# DUKE POWER COMPANY

Re: Catawba Nuclear Station  
Docket Nos. 50-413 and 50-414

## NRC INSTRUMENTATION AND CONTROL SYSTEMS BRANCH (ICSB)

## REVIEW MEETING ON CATAWBA FSAR

Figure 7.2.1-1  
(16 of 16)

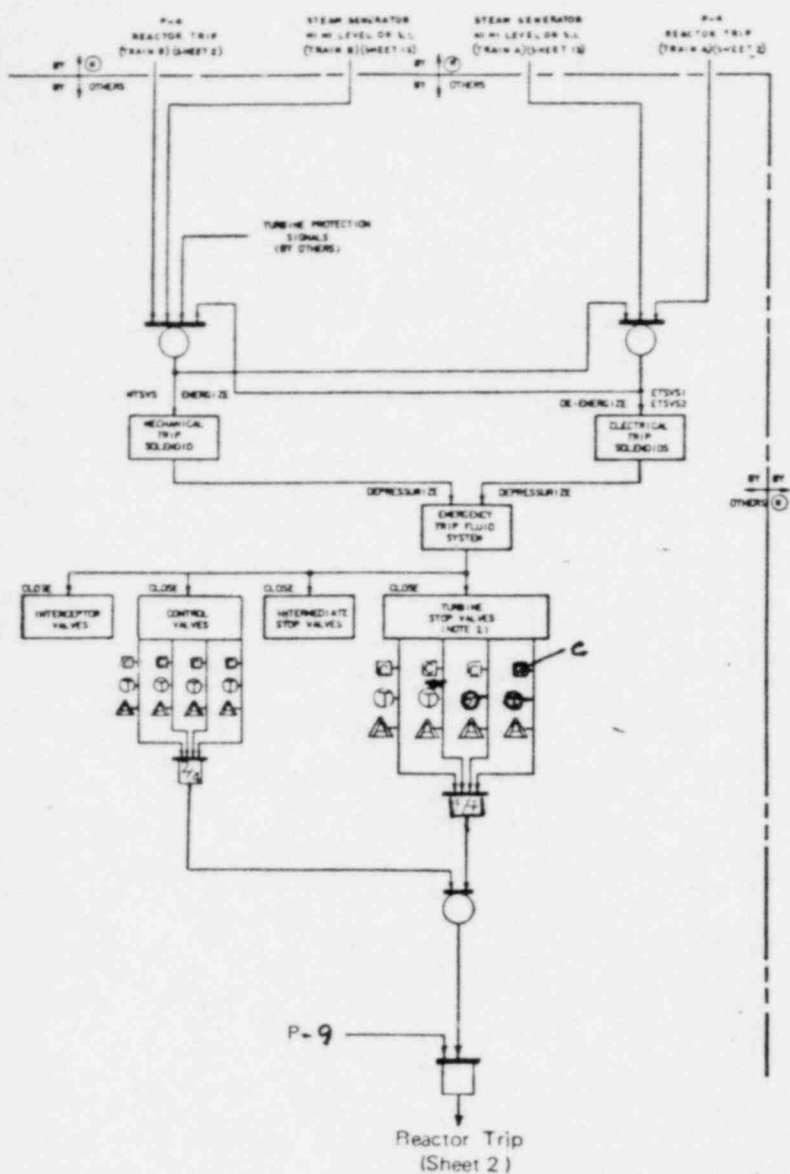
49. Discuss the method of redundantly tripping the turbine following receipt of reactor protection signals requiring turbine trip.

Duke agreed to revise Figure 7.2.1-1 (16 of 16).

Figure 7.6.21-1

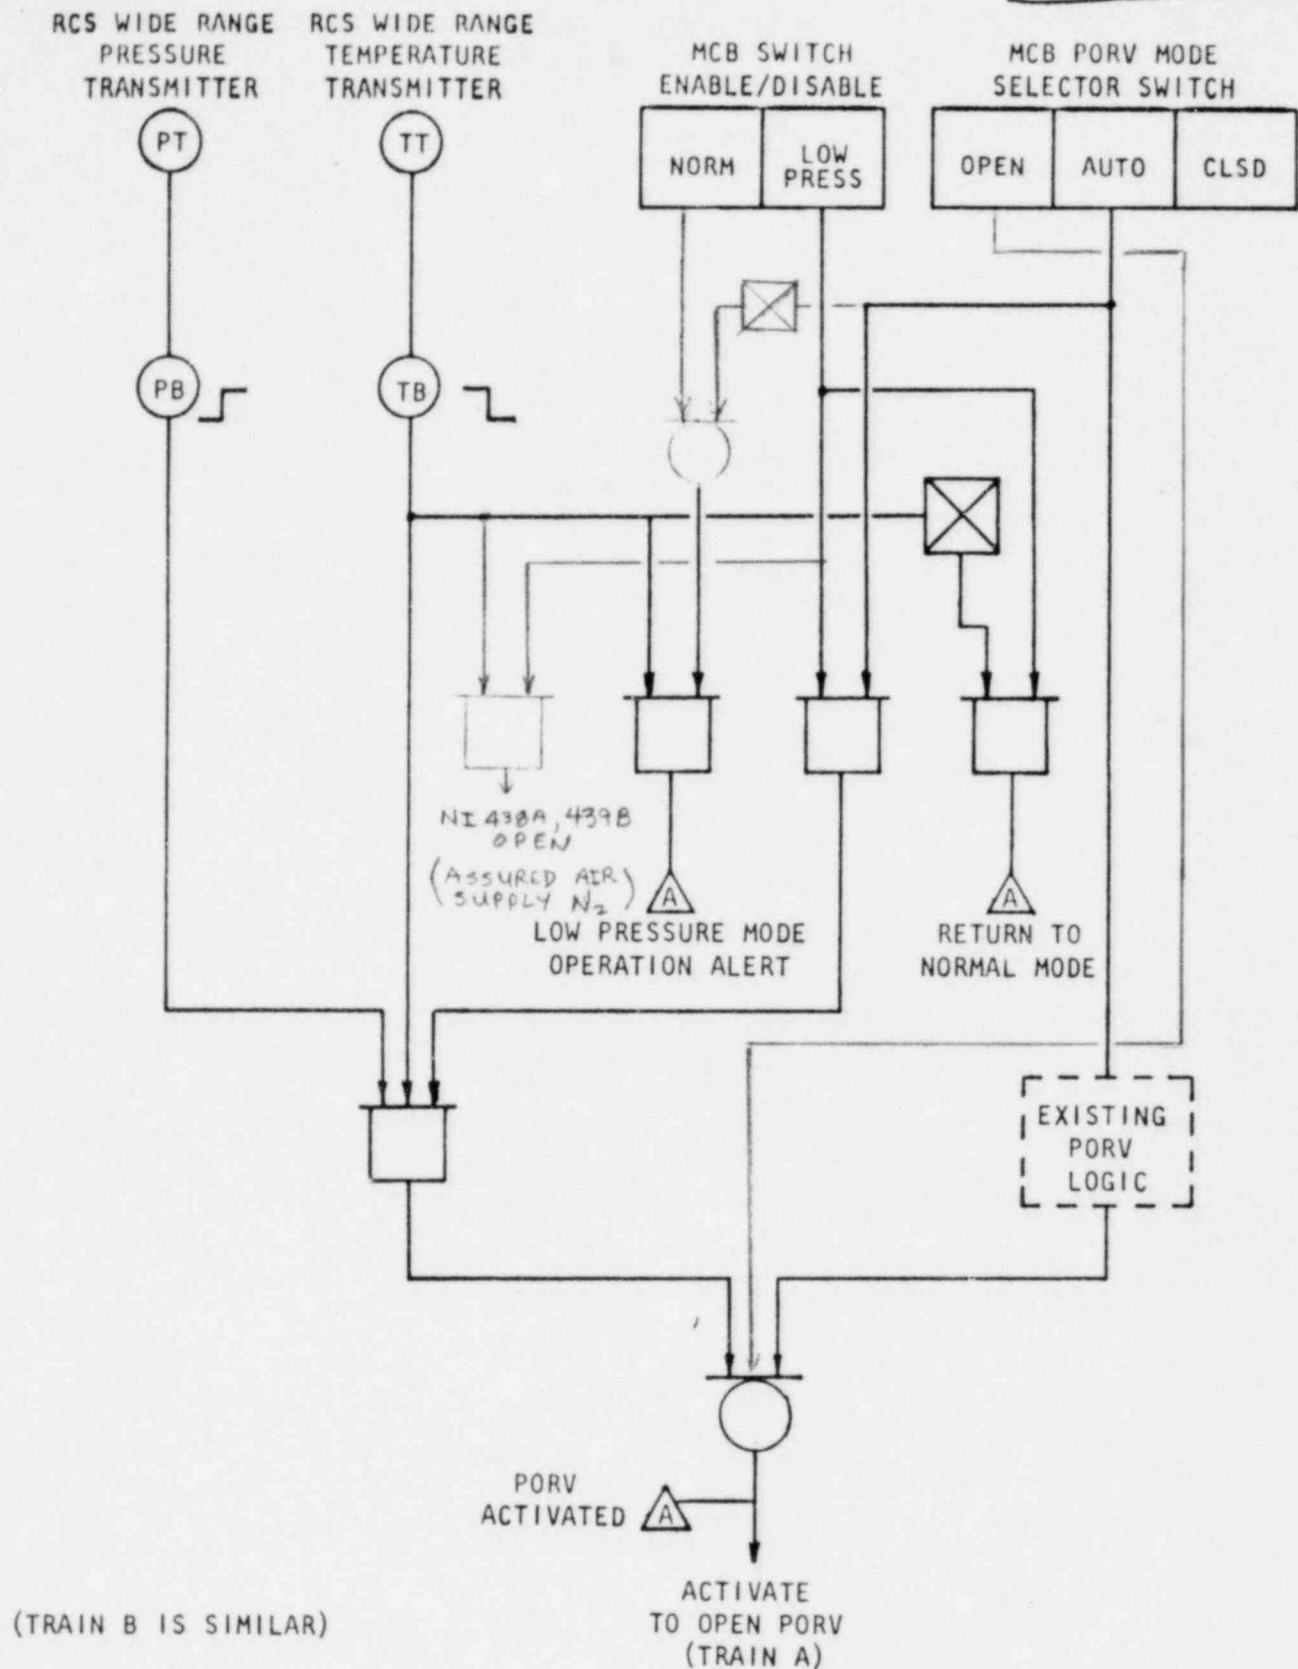
51. Using detailed schematics, describe the design of the pressurizer PORV control and block valve control. Does the current design still provide for actuation of the pressurizer spray or relief valves upon a single instrument failure? Identify and describe design features which ensure that the RCS pressure is safely controlled during low temperature operation to include parameters utilized and monitored for alarm indication. Discuss the degree of redundancy in the logic for the low temperature interlock for the RCS pressure control.

Duke agreed to revise Figure 7.6.21-1.
